[EXTERNAL]For June 6 Planning Com mtg: Extend "Woonerf" /Shared Street at PRGS Site

RE: The Hilco Redevelopment Partners Infrastructure Development Plan for the PRGS should prioritize *pedestrians*' right of way on North Fairfax Street from Slaters Lane by beginning the "woonerf" at its northern entrance.

Questions for June 6, 2023 Planning Commission meeting to review Infrastructure Site Plan for Hilco development project from Martha Harris, MUSE resident.

Statement of Serge Duss of the Marina Towers Condominium Community To the Alexandria Planning Commission on June 6, 2023 Regarding Docket No. 6 Infrastructure Development Site Plan #2023-00001

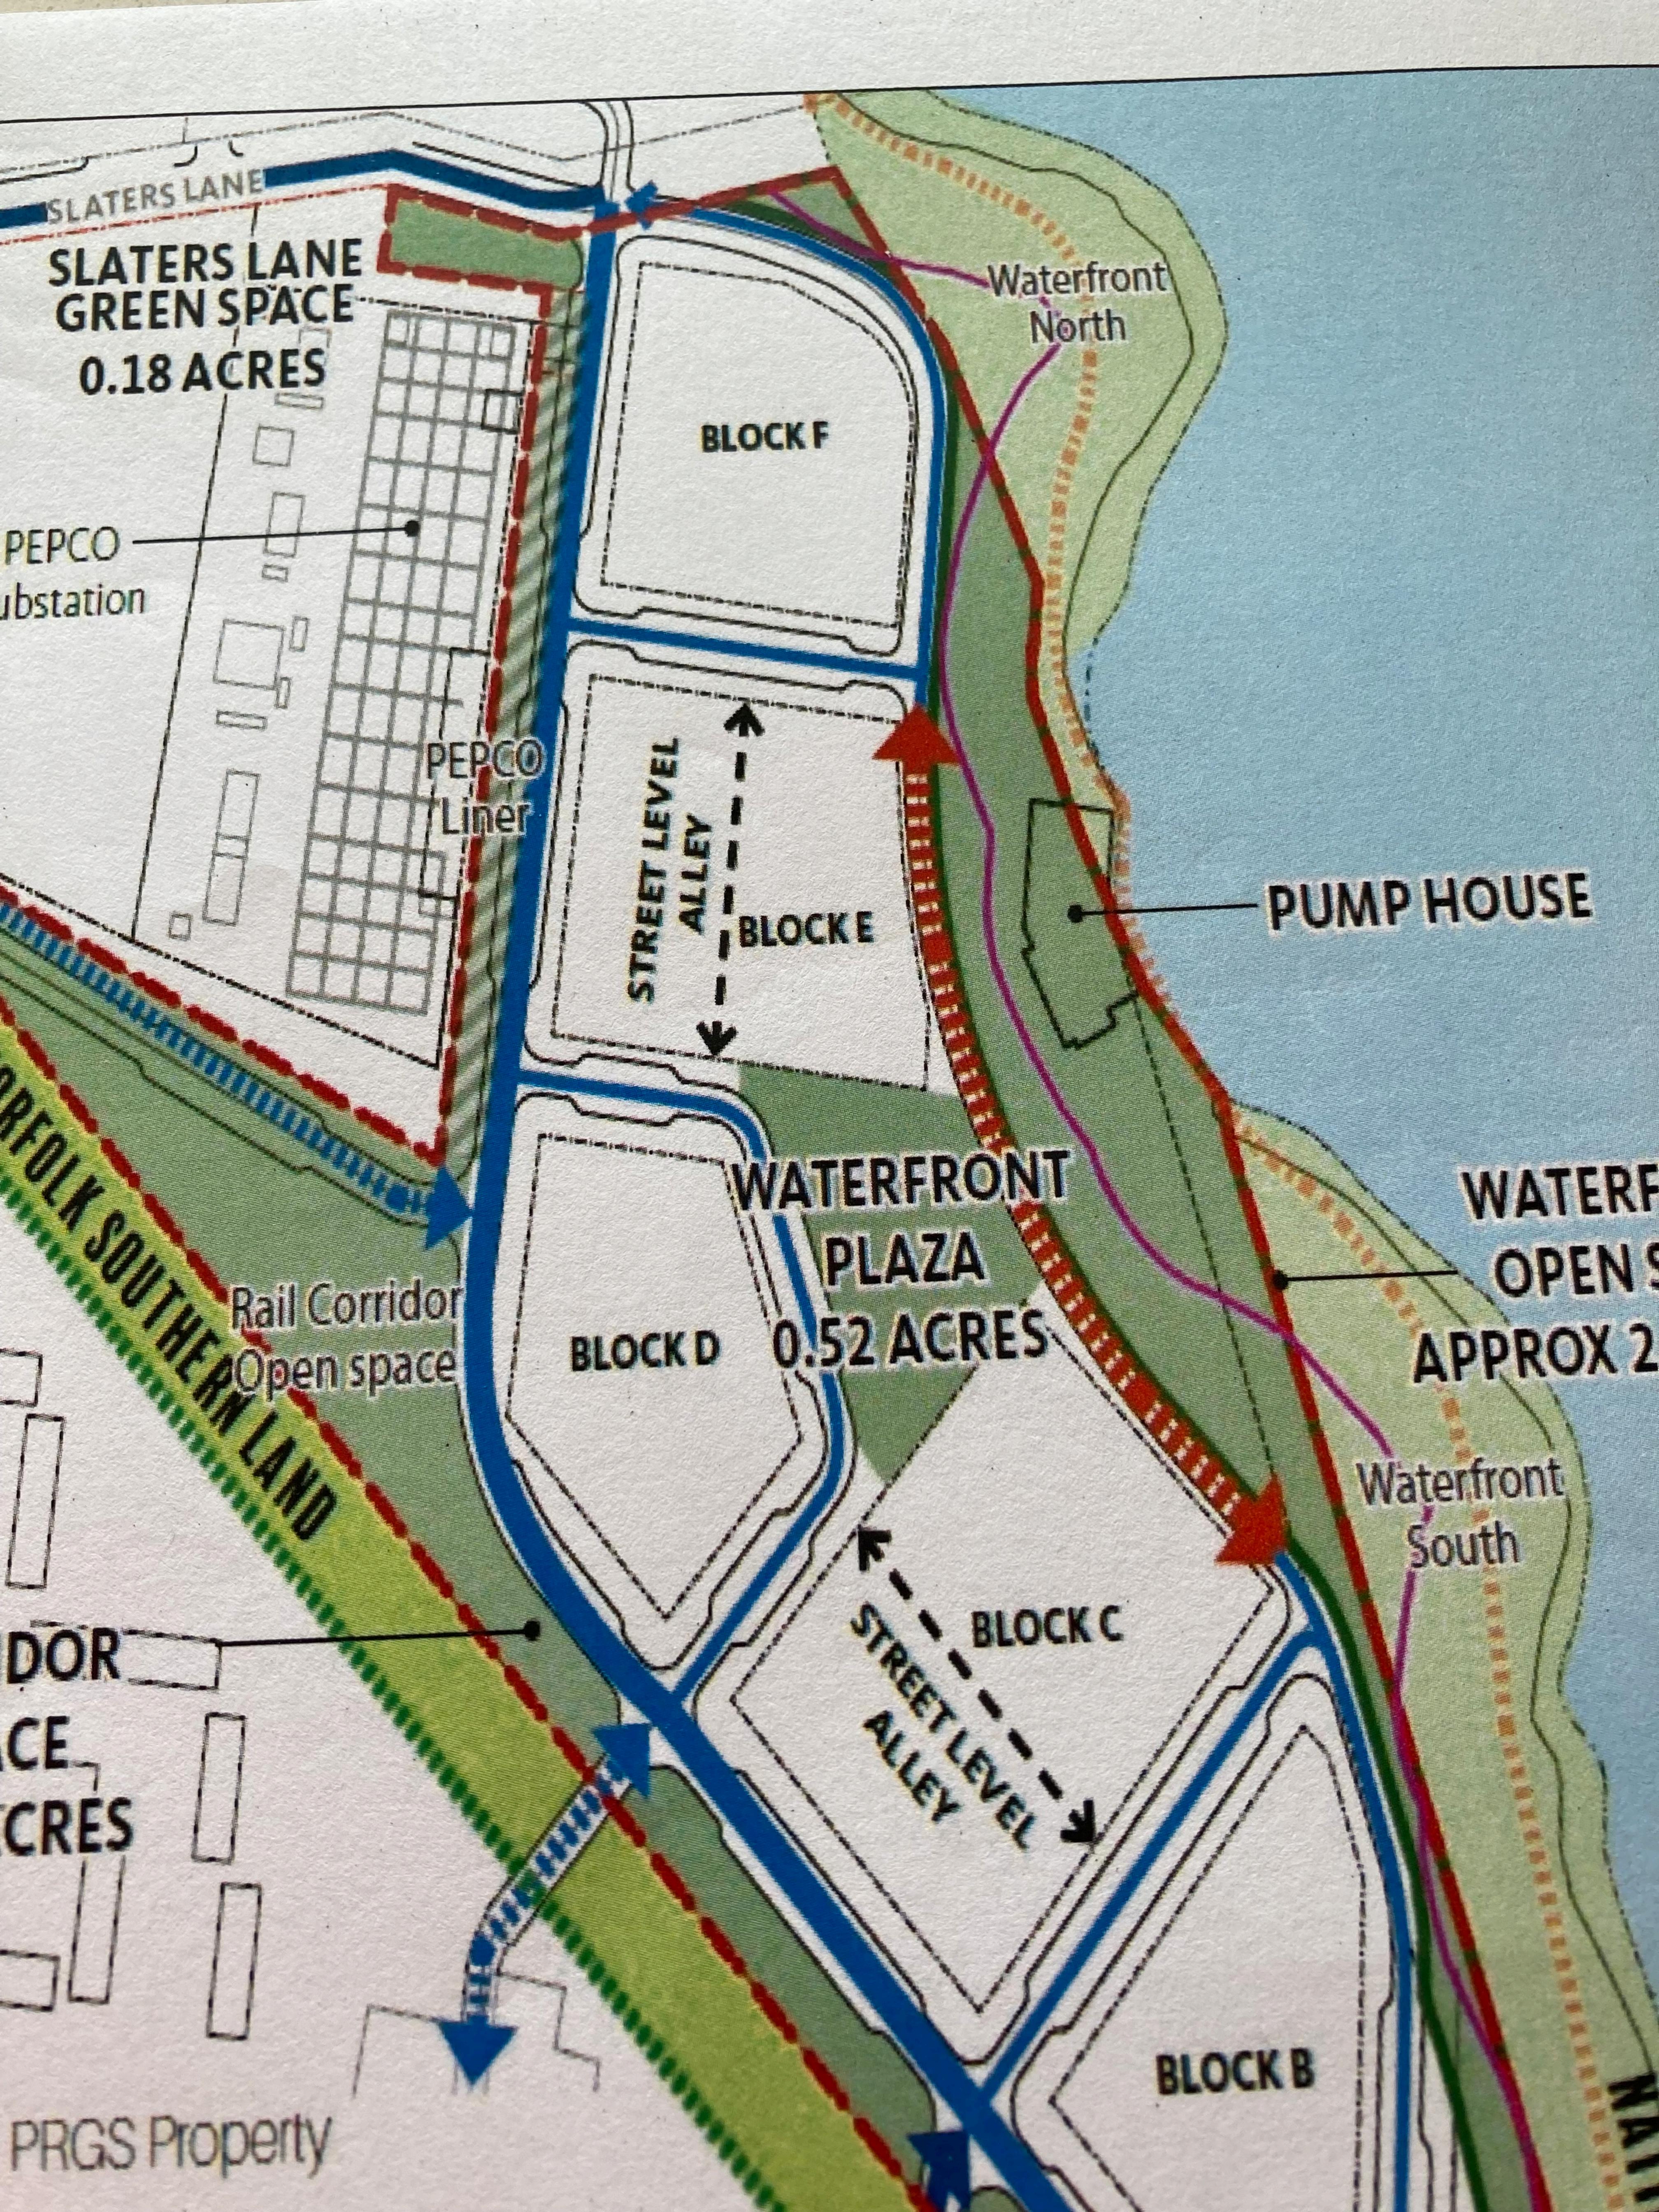
Please see attached letter and map of the "woonerf"/shared street that we ask to be extended to Slaters Lane.

The Hilco Redevelopment Partners Infrastructure Development Plan for the PRGS should prioritize *pedestrians*' right of way on North Fairfax Street from Slaters Lane by beginning the "woonerf" at its northern entrance.

We urge the Planning Commission to accept our recommendation to expand the woonerf on North Fairfax Street to realize the vision of pedestrian priority in the public realm and welcome pedestrians to North Fairfax Street from Slaters Lane.
